PRAIRIE ISLAND INDIAN COMMUNITY  
LEGAL DEPARTMENT

Re: Comments on the final EIS for PUC Docket E002/CN-08-509 (Extended Power Uprate) and PUC Docket E002/GS-08-690 (Site Permit Application)

Time

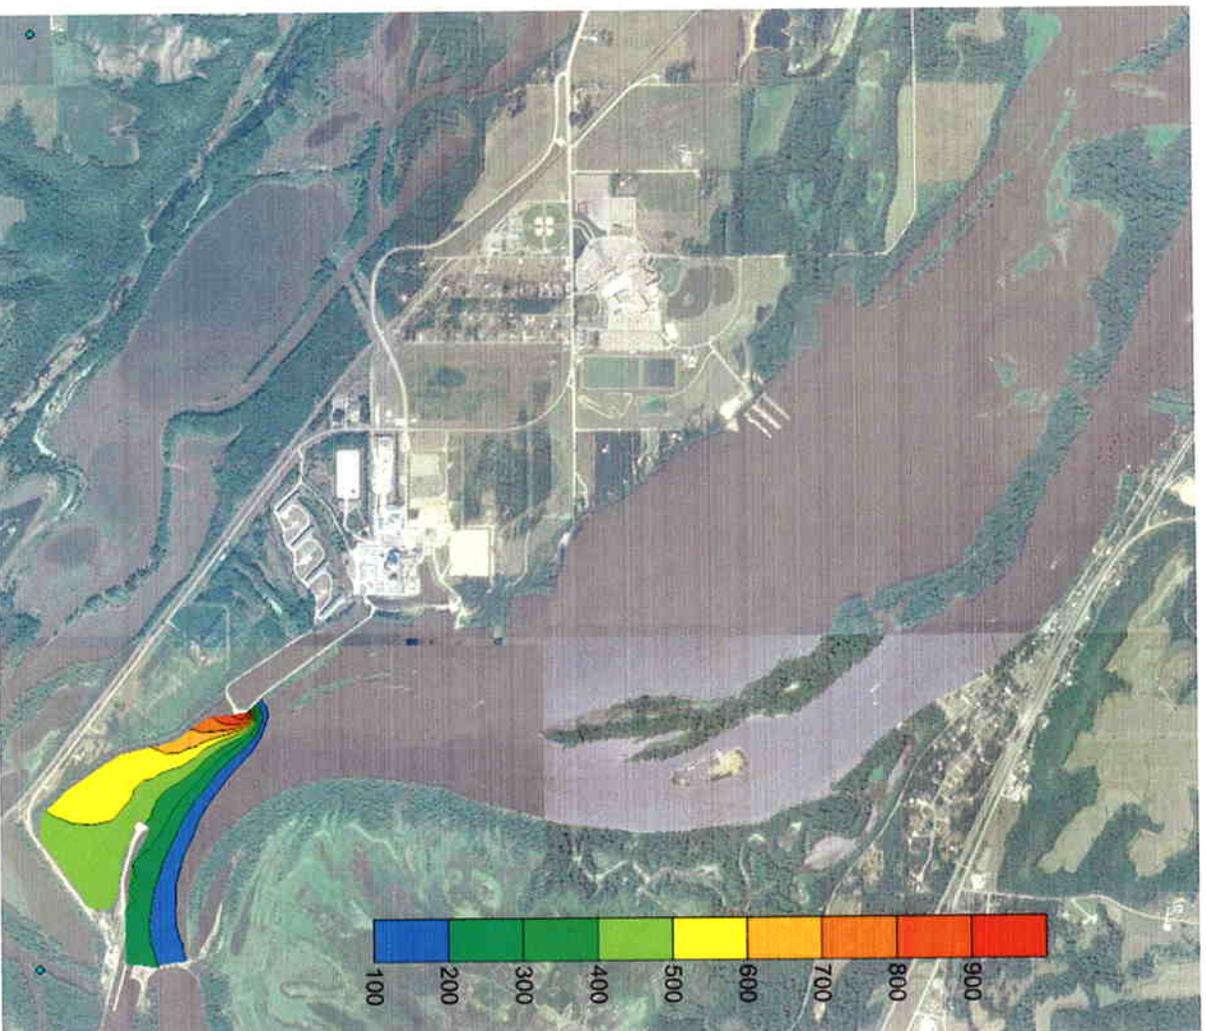
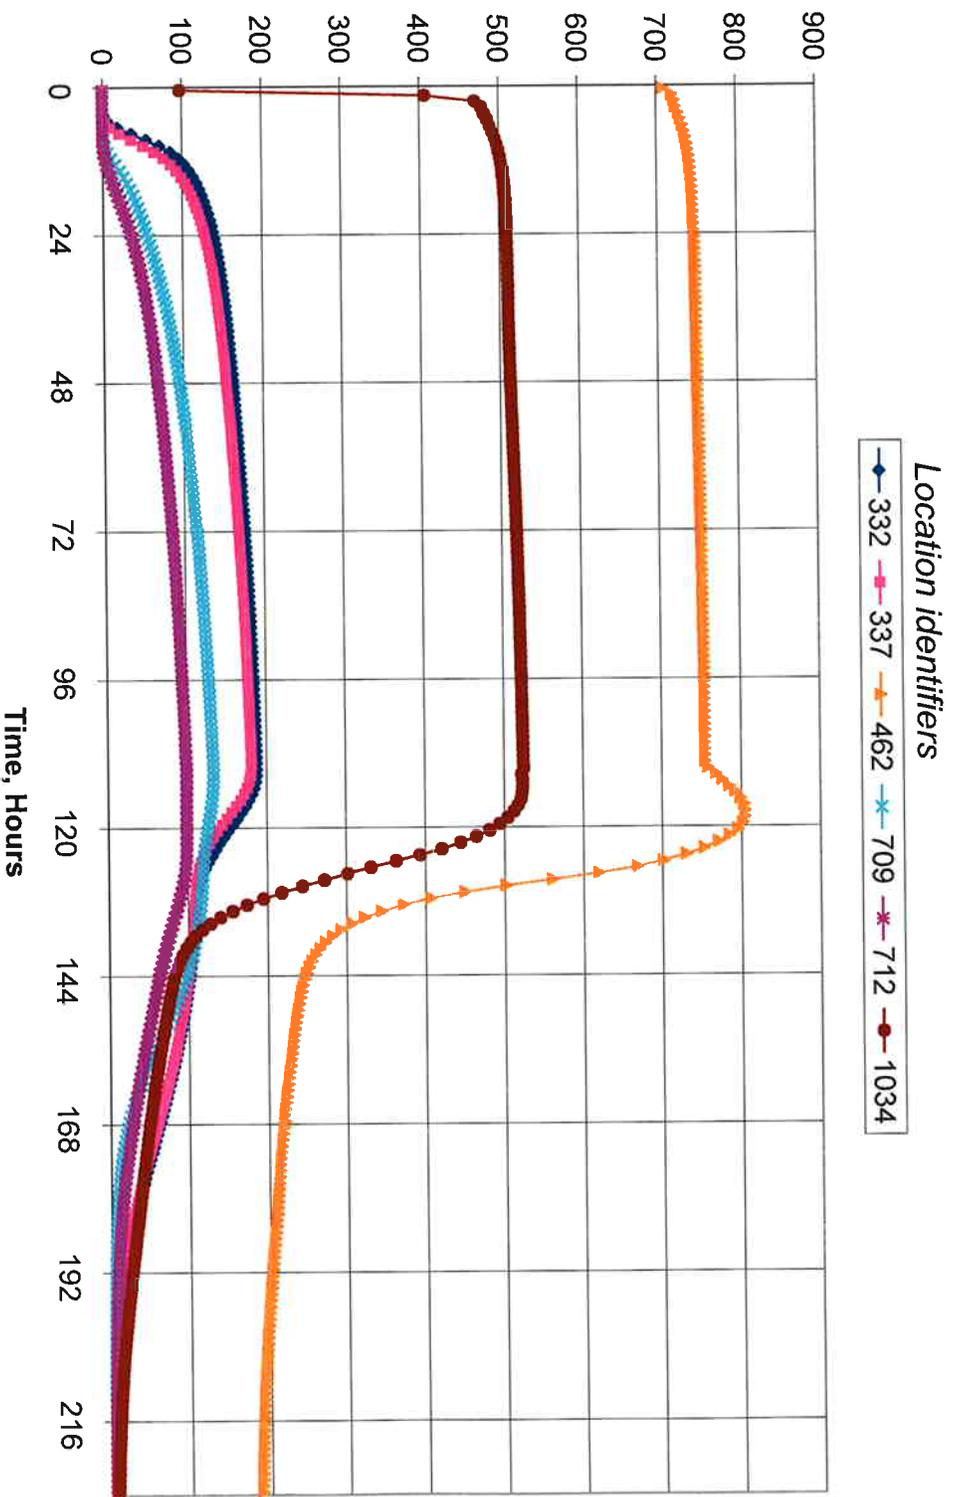
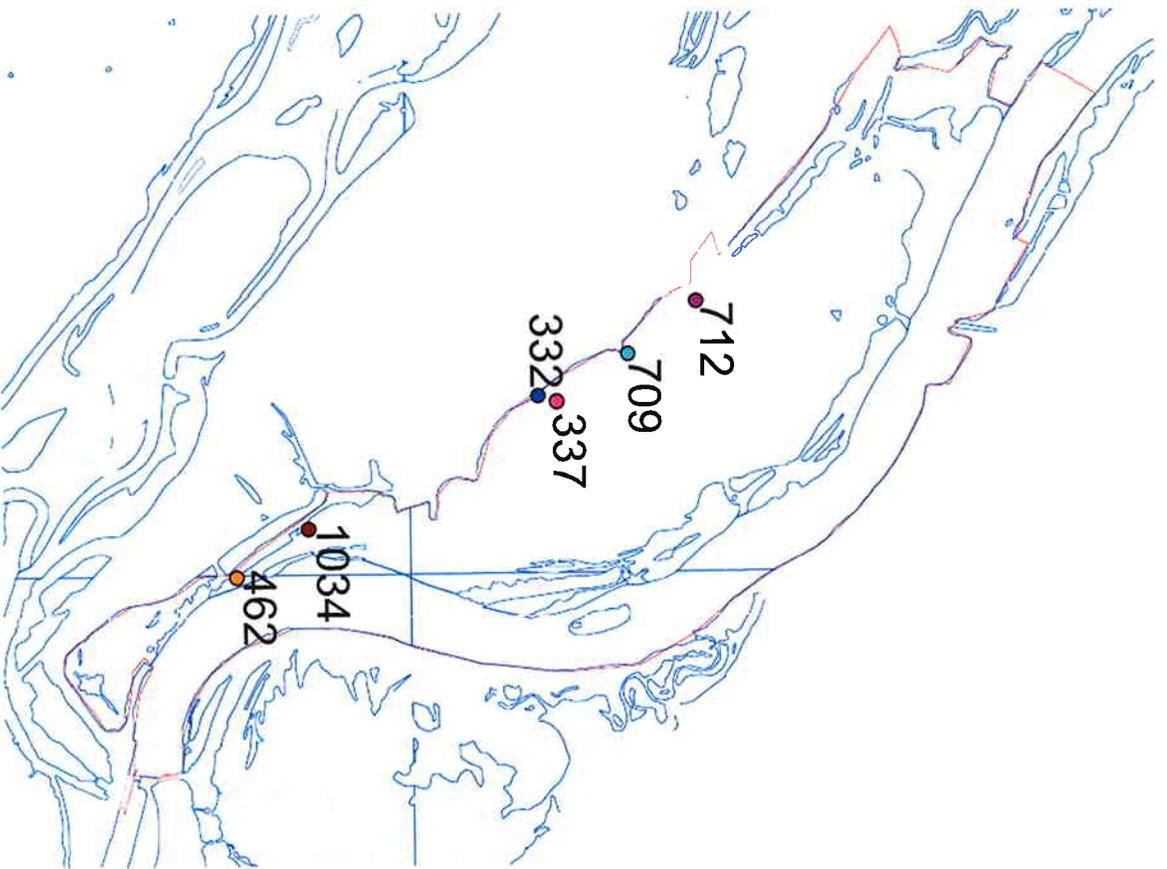
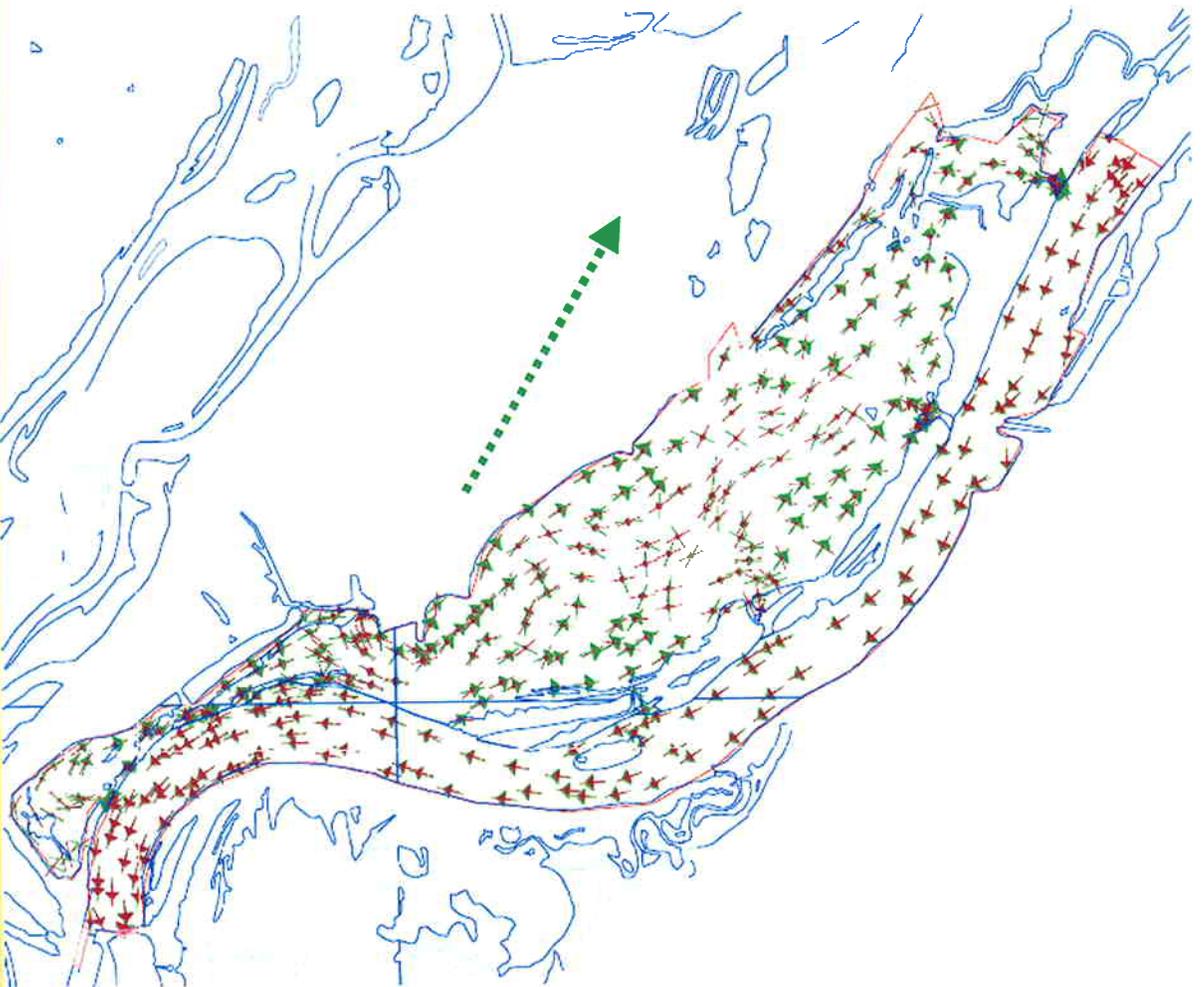
Another Study H.G. Stefan also demonstrated that the surface waters of the river actually flow back upstream (back to Sturgeon Lake) when winds are out of the S, SE, SW, E or W (varying with the speed of the wind). As we noted in our draft EIS comments, this would certainly impact not only the thermal pollution -- instead of distributing and discharging downstream, it would be pushed back upstream, potentially impacting aquatic species, like the federally-listed Higgins eye mussel. This could also potentially affect the radiological effluents from the PINGP as well.

We support the DNR's recommendation that, as a condition of the site permit, Xcel Energy be required to initiate a study that would update the Stefan studies, including an analysis of impacts to Sturgeon Lake, and that Xcel be required to expand its cooling tower capacity. Based on the Community's own preliminary analysis, the potential for adverse impacts upstream remain very real – and as of yet unaddressed – in the FEIS. See Exhibit 1.

Quarterly Values of Net Power Generation and Tritium Emissions, P1-NGP 1974-2007

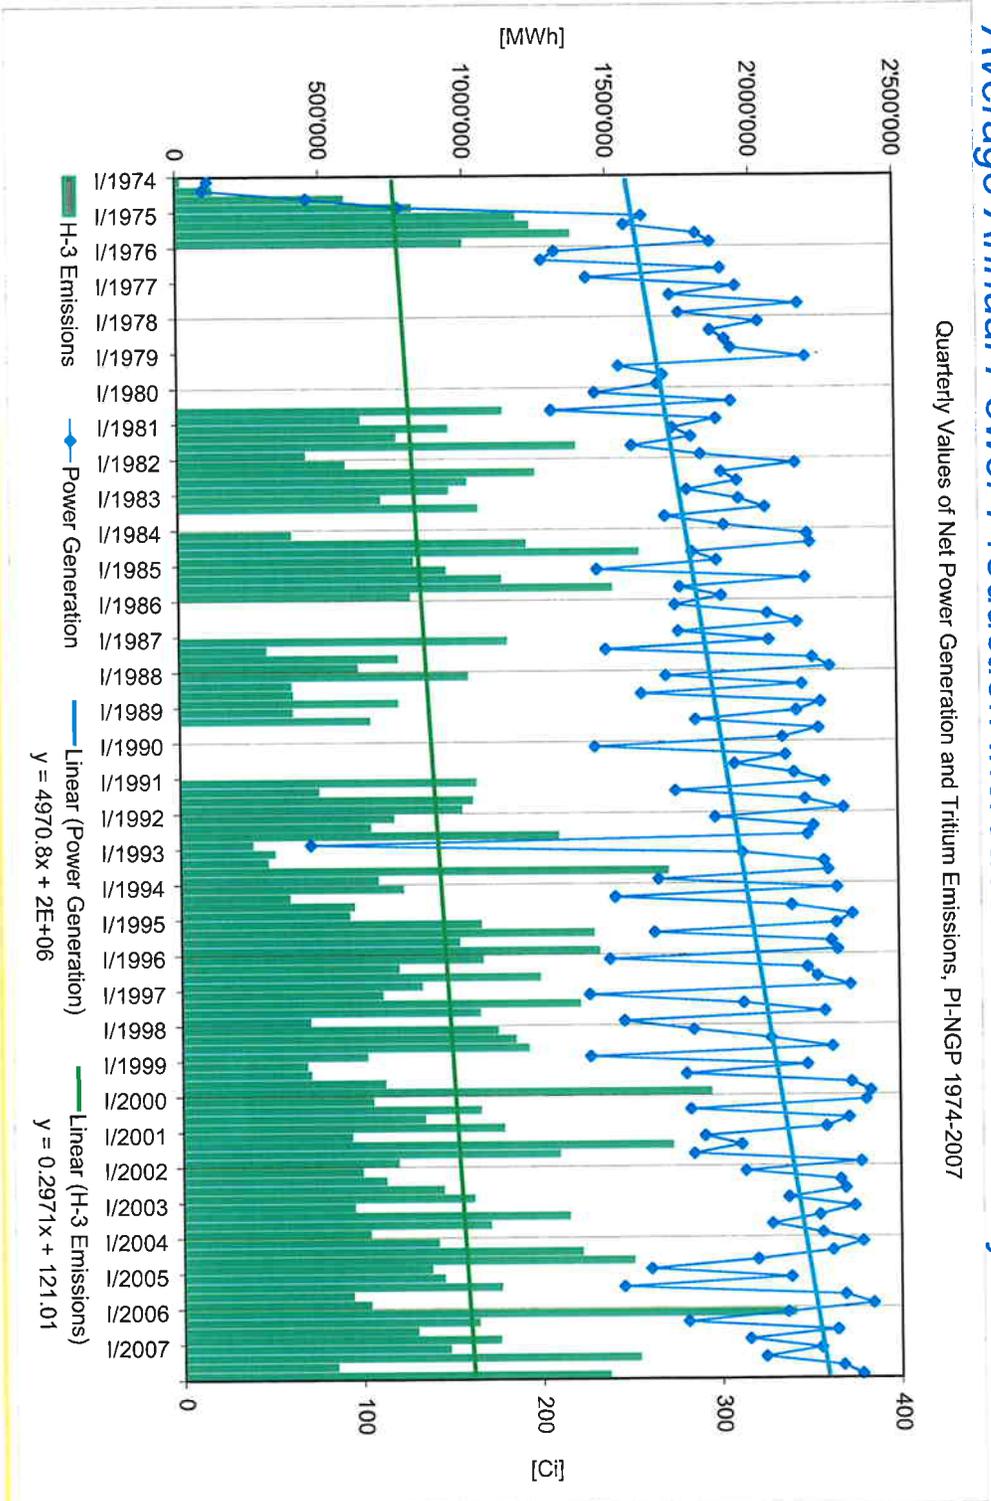
The FEIS also fails to address the possible causes of highly fluctuating and gradually increasing Tritium emissions from PINGP in the recent years into both the water and atmosphere. See Exhibit 2. Tritium, of course, is considered a tracer for all radioactive contaminants that are found in PINGP's emissions. These tritium (and other radioactive contaminant) emissions would be carried by the Southeast wind toward the PIIC Reservation, and toward other communities and members of the public under other wind scenarios.

DWG NO. B-13013 SH 1

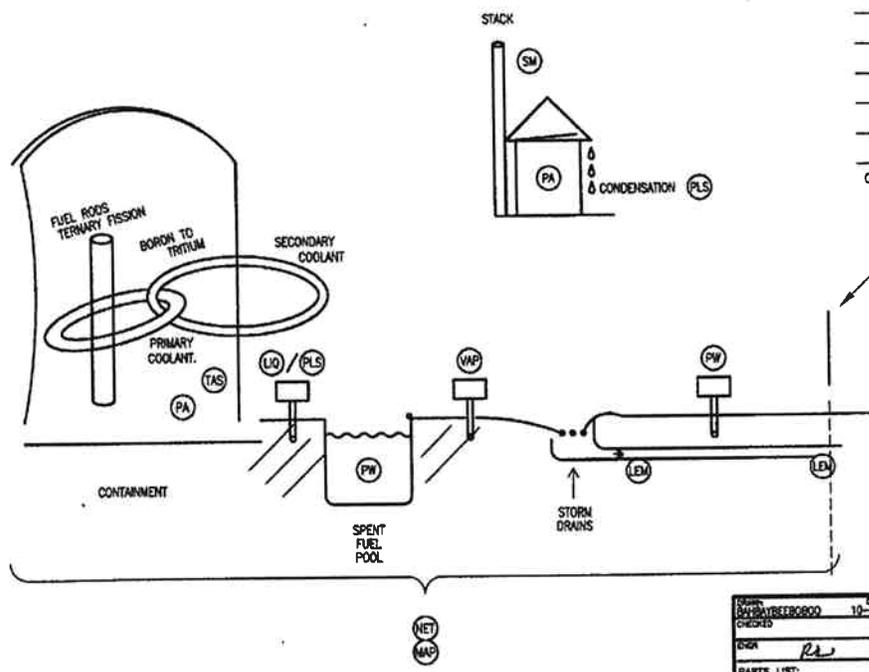
Exhibit 3, which is provided by Technical Associates, Inc., illustrate the similar schematic blue print of the primary and secondary cycles of cooling water for all pressurized water reactors, such as those operated by Xcel-PINGP. What is missing from the standard diagram is the “tertiary cycle of cooling water” of more critical importance to the evaluation of the radioactive (solid, liquid and gaseous) wastes generated by the PWRs, known as the Chemical and Volume Control System (CVCS) process, the operating data and information of which can and should be requested from Xcel and the NRC for a comprehensive investigation of the possible causes of the fluctuations and gradually increasing trends of radioactive effluents (and their radionuclides concentrations), and possibly other leakage events associated with the CVCS process.
